Towing Package Retrofit

Classification	Parts and Accessories Bulletin	Section/Group	90 - Accessories	Country/Region	North America
Year	All	Model	Model X	Version	All

This Service Bulletin supersedes SB-16-90-003, dated 09-Feb-17. Each content change is marked by a vertical line in the left margin. Discard the previous version and replace it with this one.

Figure 4 (Diffuser revision A)

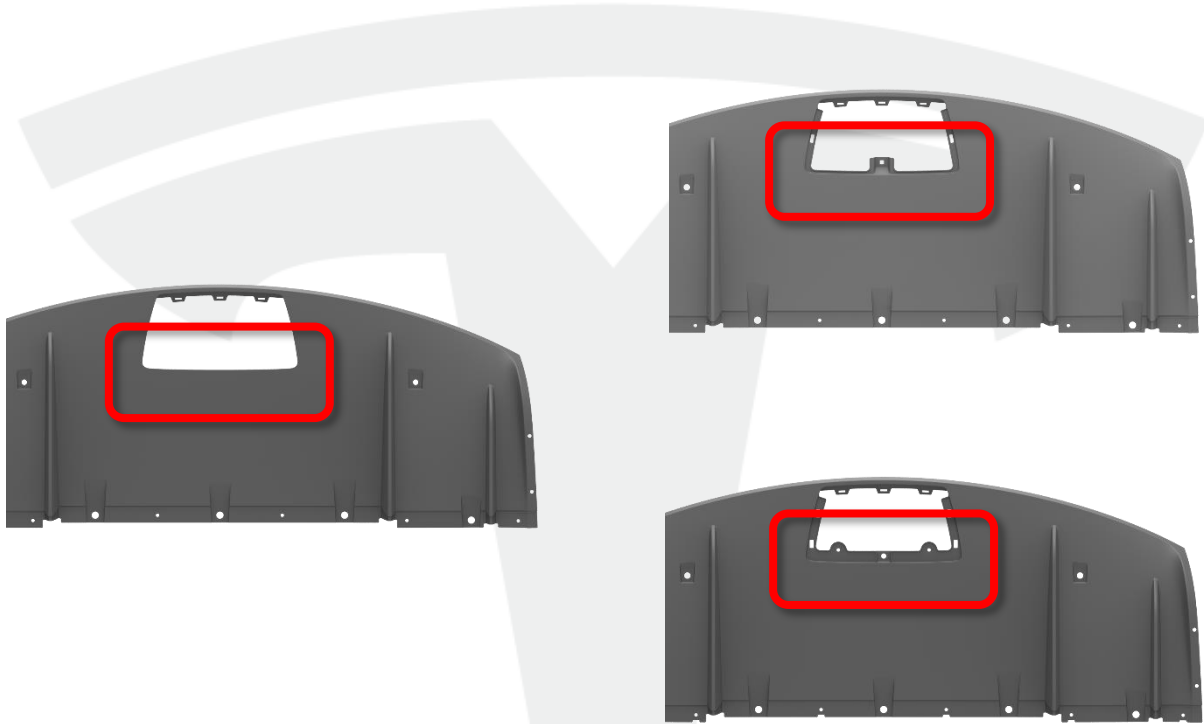
1. Remove the rear bumper assembly (refer to Service Manual procedure 10013102).
2. Determine if the rear diffuser should be replaced (Figure 4 and Figure 5):
 - If the diffuser is part number 1058356-00-A: Discard the diffuser and access cover, and then do the following:
 - a. Replace the rear diffuser panel with part number 1058356-00-C (refer to Service Manual procedure 12030802)
 - b. Replace the tow hitch access cover with part number 1058357-00-D.
 - If the diffuser panel is part number 1058356-00-B or later: Continue this procedure.
